Project	233 Uxbridge High St	Project description	New banqueting hall and Hotel	Scale	1:100@A1	Job No	0242
Title	North Elevation	Stage	Planning	Drawing No	A213	Rev	01

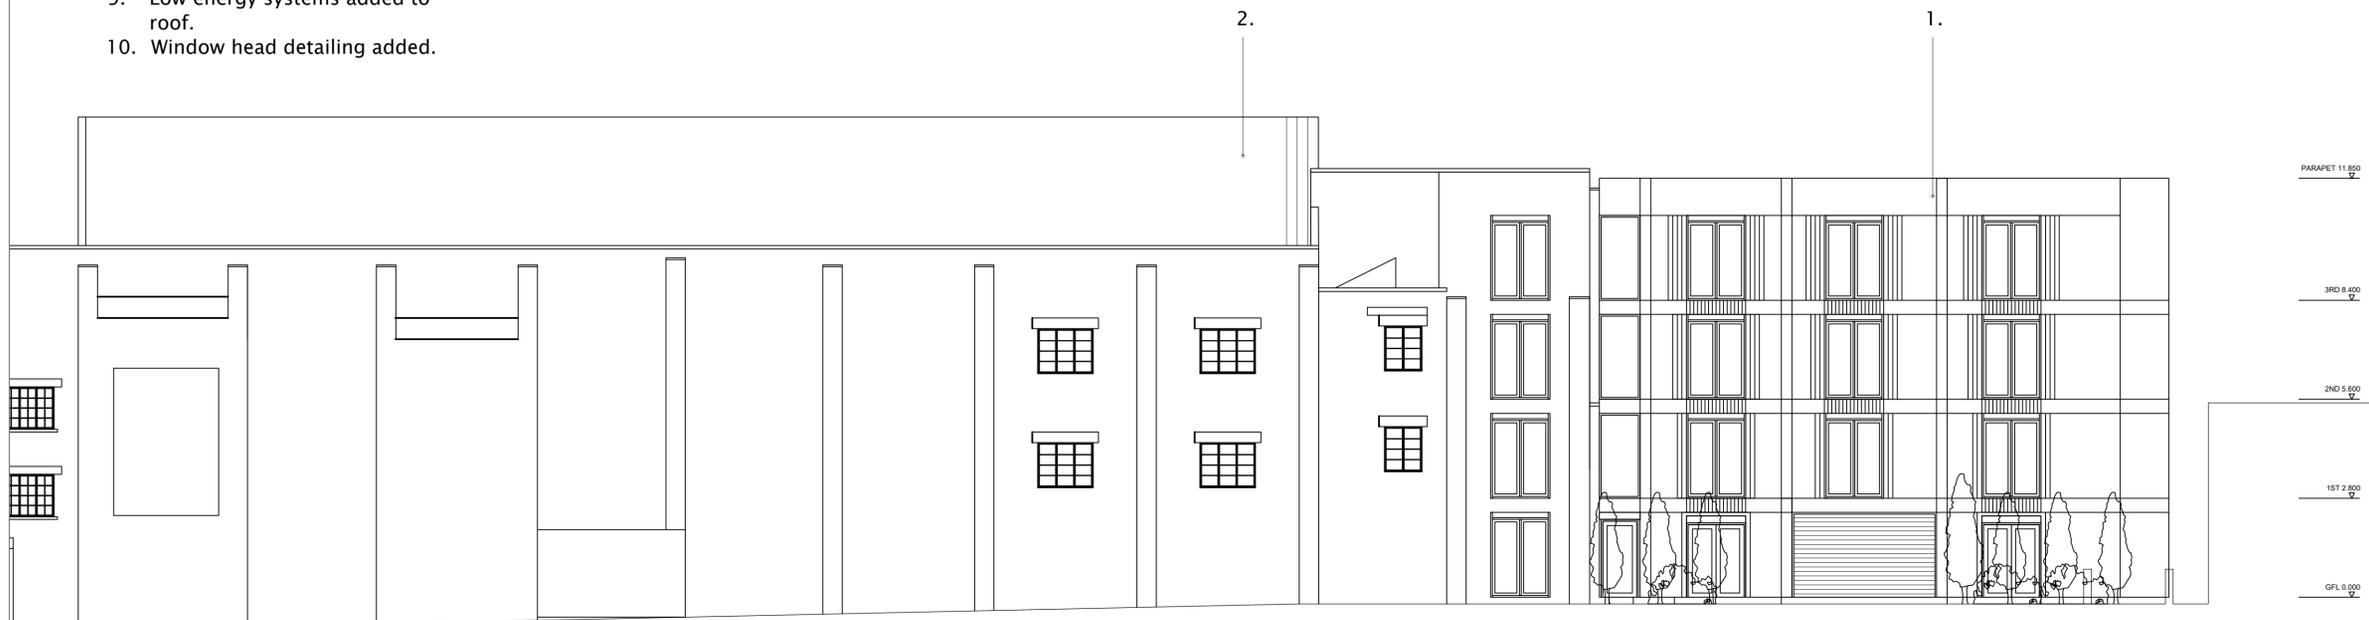
1. Basement redesigned and access flipped as requested. Access is via road at Cumbrian way.
2. Ramp has been removed and a car lift proposed. This offers more space in the basement and better turning capacity. In addition the ramp access has been removed from the front elevation.
3. Trees shown for BNG.
4. Hotel rooms revised to be Part M compliant.
5. Lift to frontages of hotel and listed building.
6. Soft landscaping and terracing to front of hotel.
7. Pathways and alley improved with landscaping.
8. Oriel windows added to the southern elevation to mitigate overlooking.
9. Low energy systems added to roof.
10. Window head detailing added.
